Access Compliance Report Public Rights-of-Way (Curb Ramps)

Main Street: MAIN_ST Cross Street: ORANGE_OLIVE_RD Location: E

ADA ID: RPAT220127120500 Ramp Type: Type 7 - Directional 2 Initial Pass/Fail: Fail Overall Compliance: No Severity Score: 2

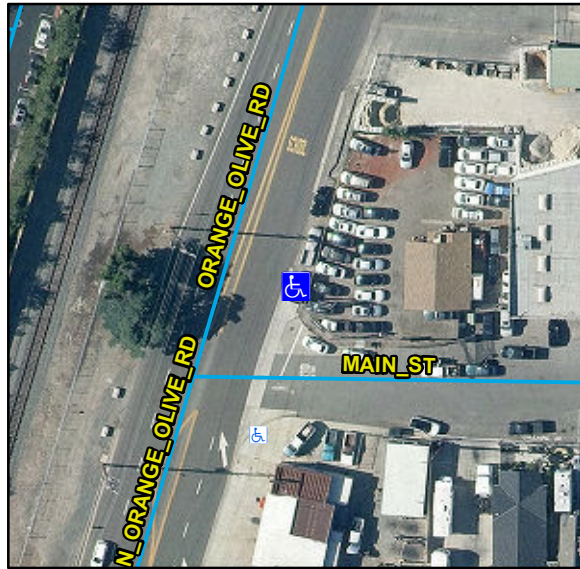
Compliance	Description	Data	Compliance	Description	Data
N/A	Ramp Length (in)	151	N/A	Flare Type LT	
Yes	Ramp Width (in)	89			N/A
Yes	Ramp Run Slope (%)	4.6	N/A	Flare Slope LT (%)	N/A
No	Ramp Cross Slope (%)	2.6	N/A	Flare Traversable LT	N/A
N/A	Grade Break	N/A	N/A	Flare Type RT	
N/A	Grade Break Slope (%)	N/A			N/A
N/A	Grade Break Cross Slope (%)	N/A	N/A	Flare Slope RT (%)	N/A
	Addl Para Ramp Left?	No	N/A	Flare Traversable RT	N/A
	Addl Para Ramp Right?	No	N/A	DWS Provided	N/A
N/A	Landing Present	N/A	N/A	DWS Contrast	N/A
N/A	Landing Length (in)	N/A	N/A	DWS Length (in)	N/A
N/A	Landing Width (in)	N/A	N/A	DWS Full Width	N/A
N/A	Landing Run Slope (%)	N/A		DWS Offset Type	N/A
N/A	Landing Cross Slope (%)	N/A	N/A	DWS Left Offset (in)	N/A
N/A	Landing Movement Obstructed?	N/A	N/A	DWS Right Offset (in)	N/A
	Landing Movement Type	N/A			
N/A	Landing Shared	N/A			
N/A	Marked Crosswalk 1	No	N/A	Clear Space	N/A
	Crossing 1 Direction	SW	N/A	Clear Space To Crosswalk (in)	N/A

Marked Crosswalk 1 Width (in)	N/A			
N/A	Ramp Inside Crosswalk 1	N/A			
	Crossing 1 Slope (%)	1.4			
	Crossing 1 Cross Slope (%)	0.1			
N/A	Gutter Ponding	N/A	N/A	Curb Slope	4.7
Yes	Gutter Lip Height (in)	0		Road Run Slope (%)	N/A
N/A	Gutter Run Slope (%)	N/A		Road Cross Slope (%)	N/A
N/A	Gutter Cross Slope (%)	N/A		Parallel Ramp Side	Left
Yes	Overall Surface Condition	Acceptable	Yes	Perp Joint Present	Yes
	Cross Gutter Present?	Yes		Spandrel Present?	Yes
	Replace Cross Gutter?	No		Replace Spandrel?	No

Remove & Replace Entire Ramp.

R304.5.3, STD 1115
